工程指示 / 要求簡箋(E.I.)

工程指示編號：EI / 1352 / 19

工程名稱：亞皆老街中電

工程項目：CANOPY 地盤用預埋碼

TITLE :
EMBED DETAILS OF
CANOPY AT LG2
EB-CAN

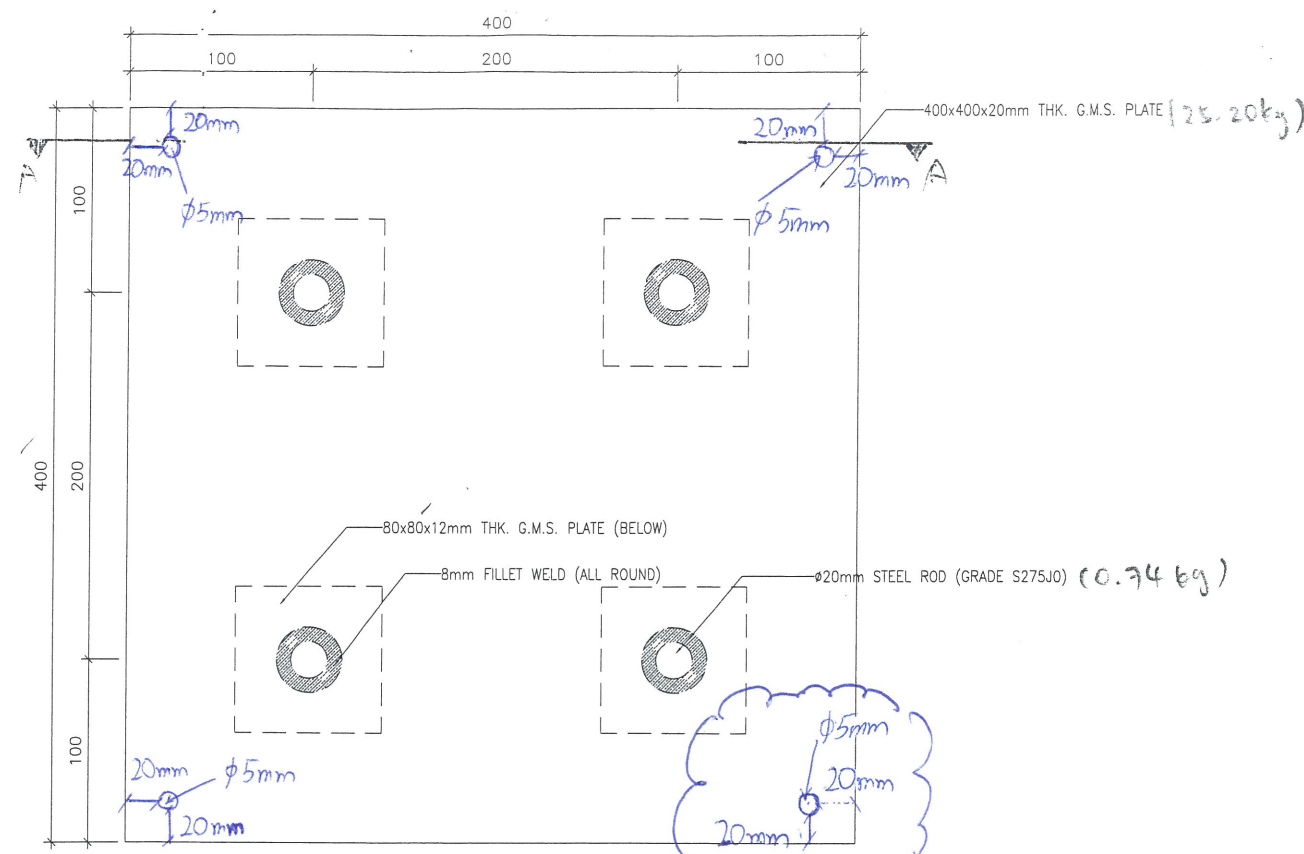
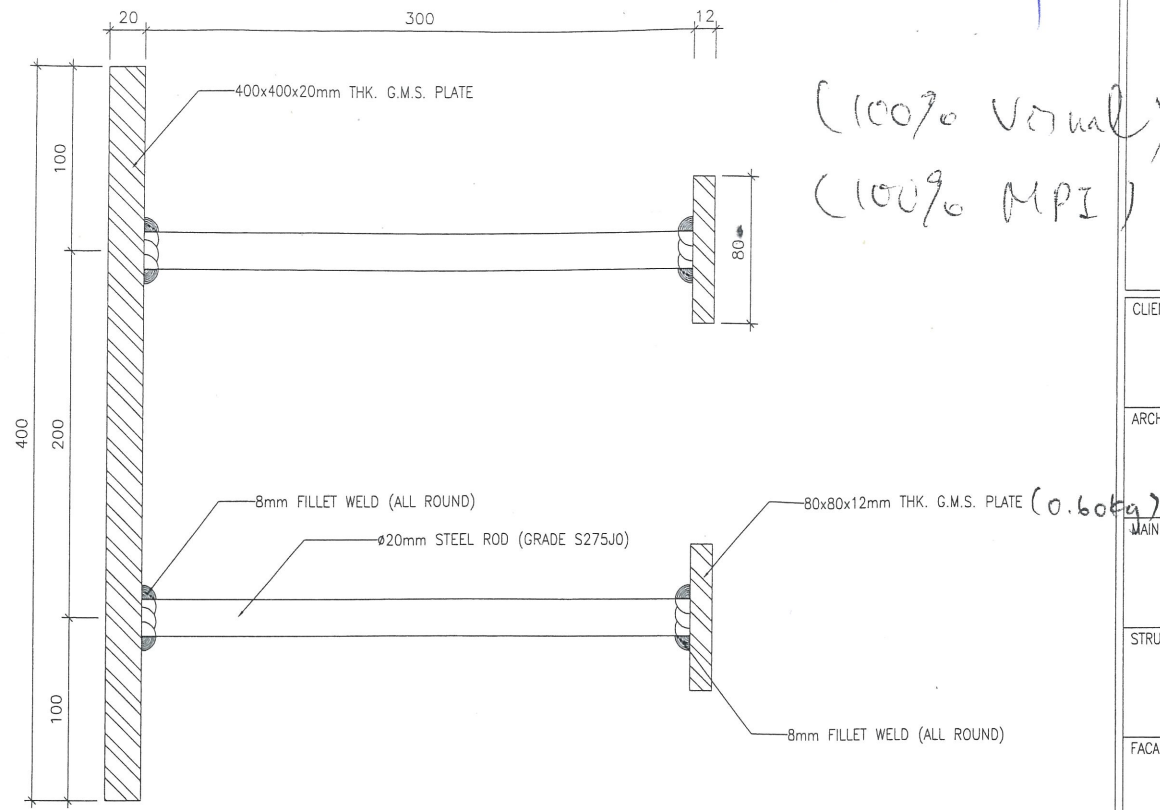
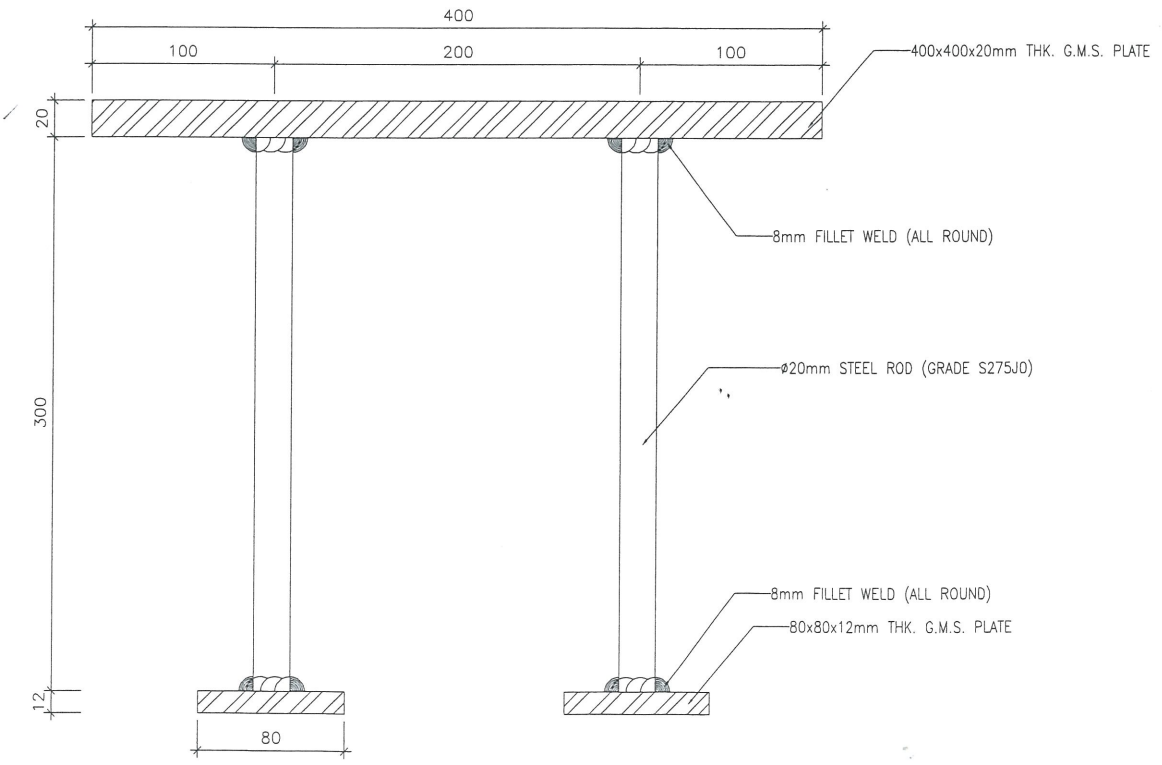
煩請按此修改預埋碼 (加開 4 個直徑為 5mm 的小孔以供預埋碼固定在釘板上)

For 釘板時連同預埋端用鐵釘收
A 版本
鐵板四角加開小孔
